# UDON SOUTH SITE DEVELOPMENT PLAN 12265 HIGHWAY 94

UDON SOUTH - PCD FILE # PPR2422

# V\_3 Site Development Plan Redline Return.pdf Markup Summary

ISSUED: 09.19.2024  
SITE PLAN  
SHEET 3 OF 3

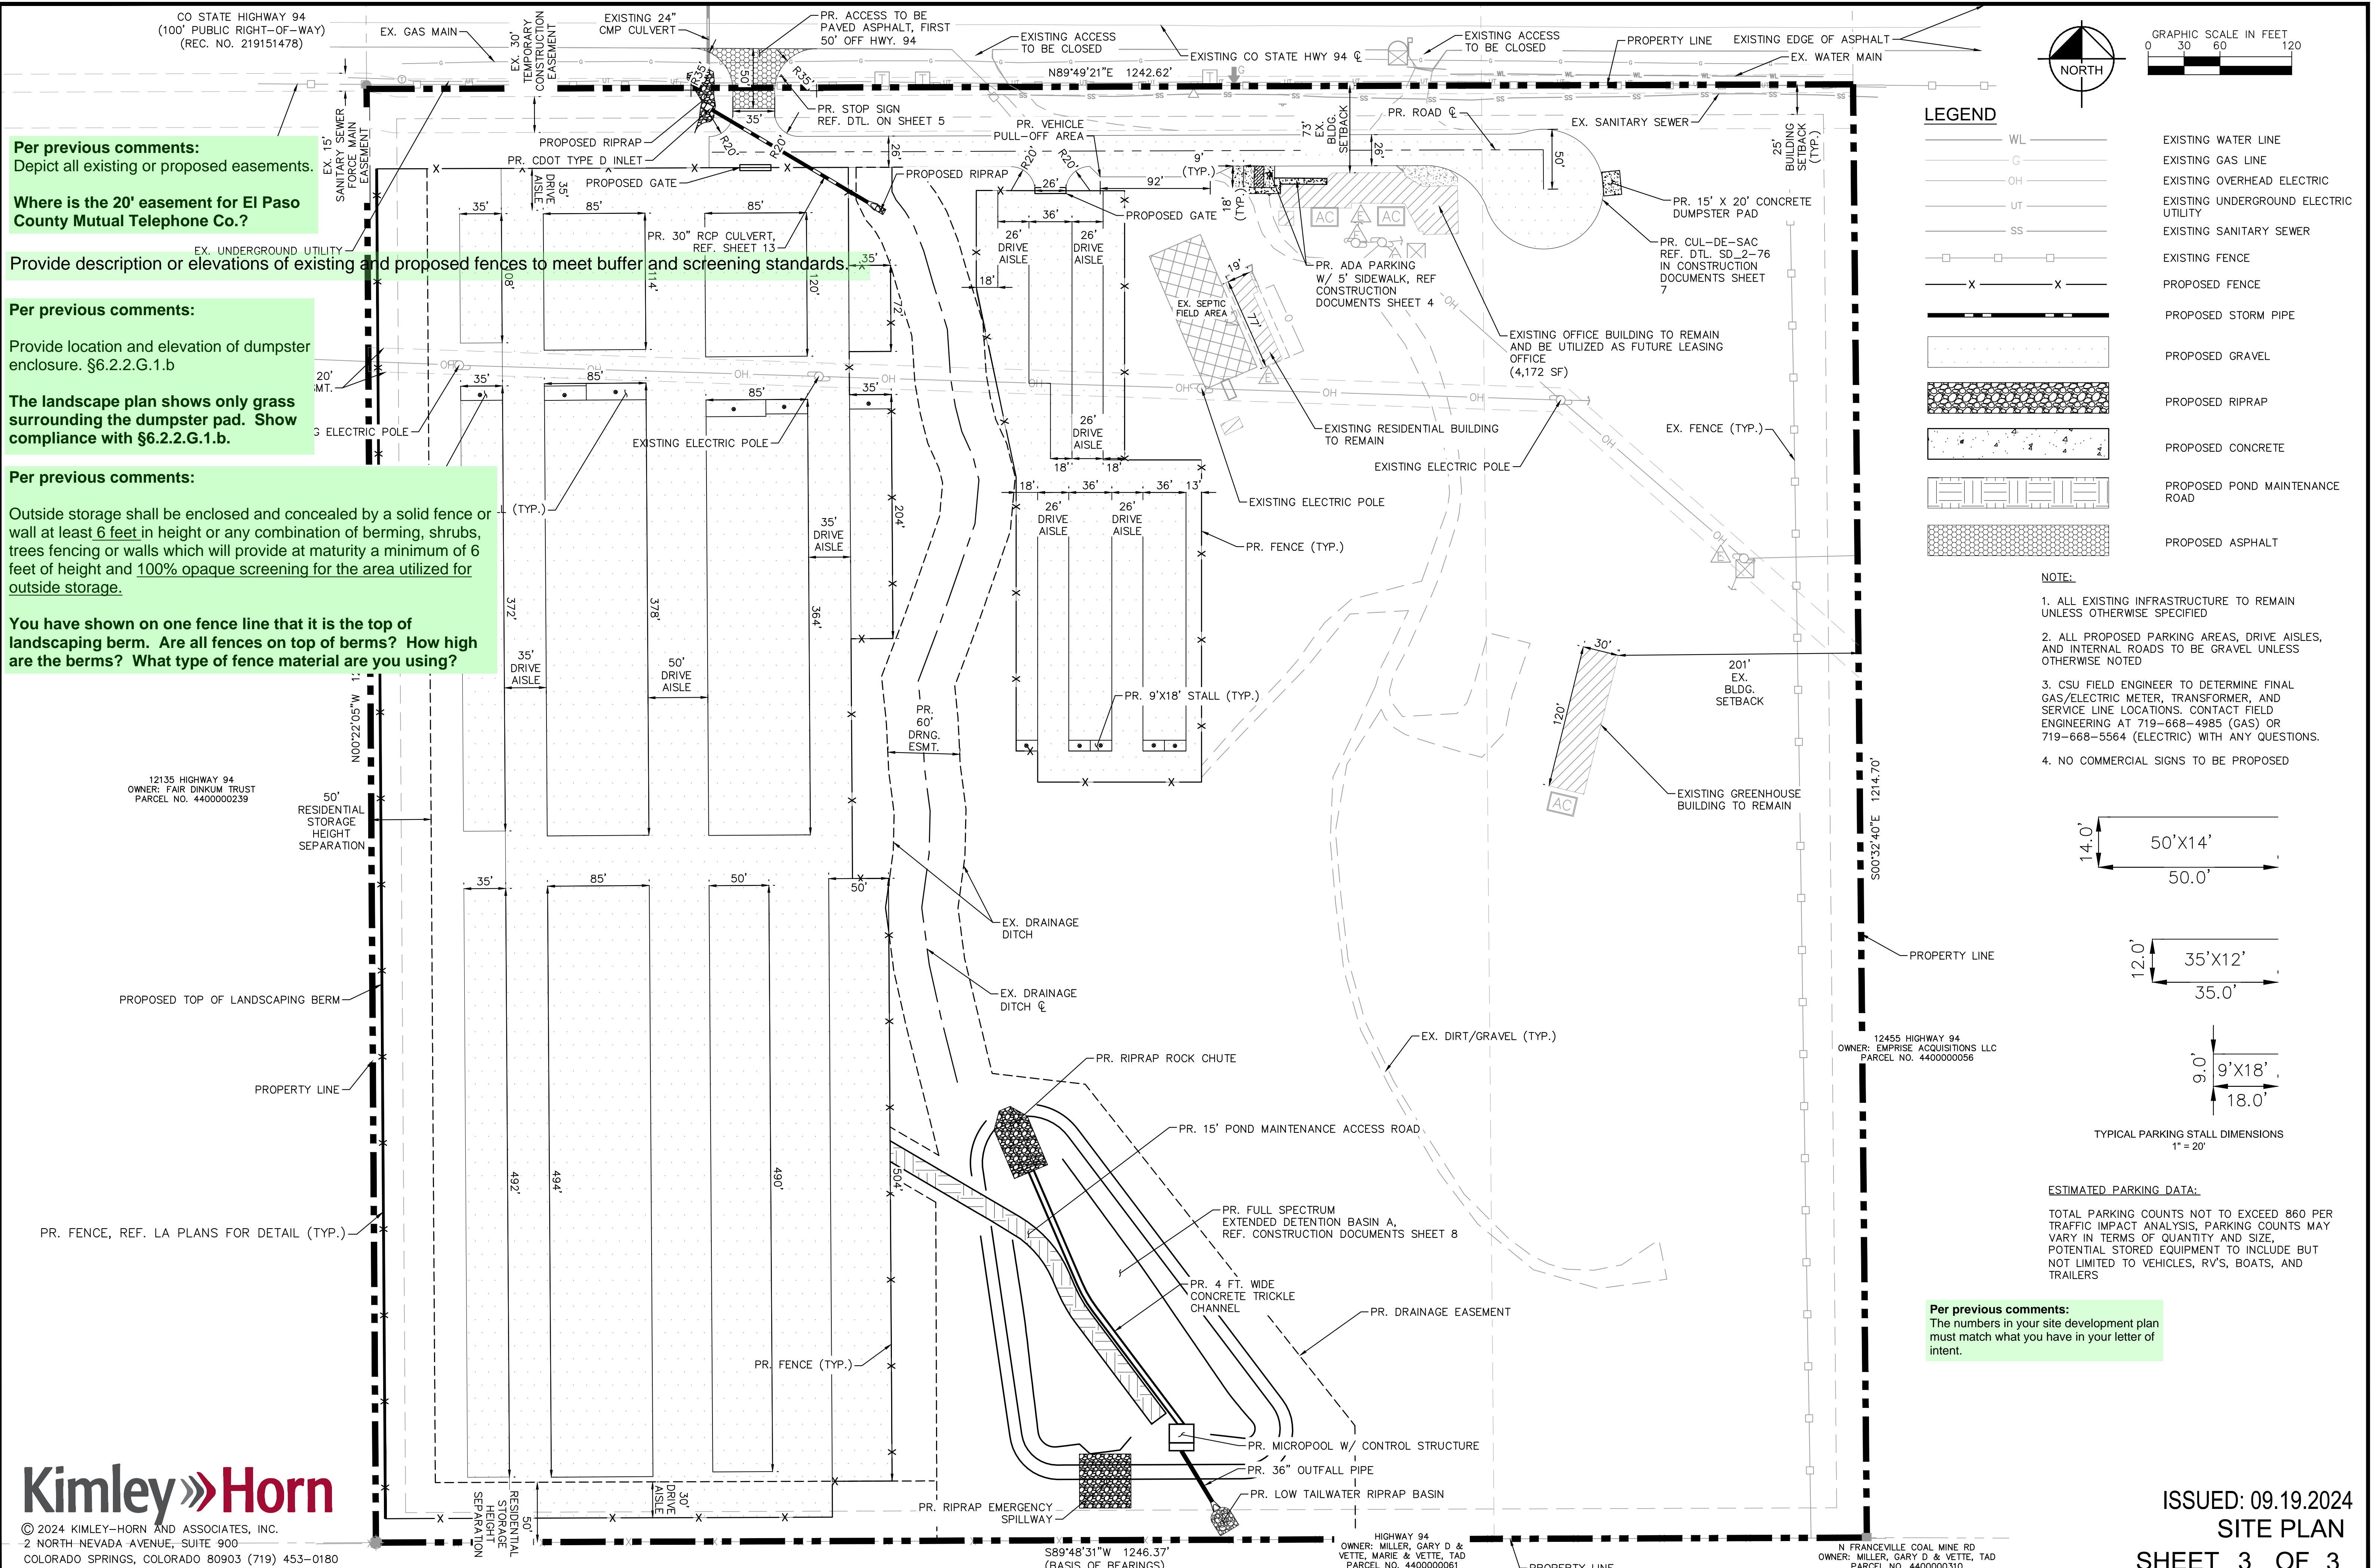
**Per previous comments:**  
Depict all existing or proposed easements.

**Where is the 20' easement for El Paso County Mutual Telephone Co.?**

**Provide description or elevations of existing and proposed fences to meet buffer and screening standards.**

**Per previous comments:**

**Provide location and elevation of dumpster enclosure. §6.2.2.G.1.b**

**The landscape plan shows only grass surrounding the dumpster pad. Show compliance with §6.2.2.G.1.b.**

**Per previous comments:**

**Outside storage shall be enclosed and concealed by a solid fence or wall at least 6 feet in height or any combination of berming, shrubs, trees fencing or walls which will provide at maturity a minimum of 6 feet of height and 100% opaque screening for the area utilized for outside storage.**

**You have shown on one fence line that it is the top of landscaping berm. Are all fences on top of berms? How high are the berms? What type of fence material are you using?**

**Per previous comments:**  
The numbers in your site development plan must match what you have in your letter of intent.
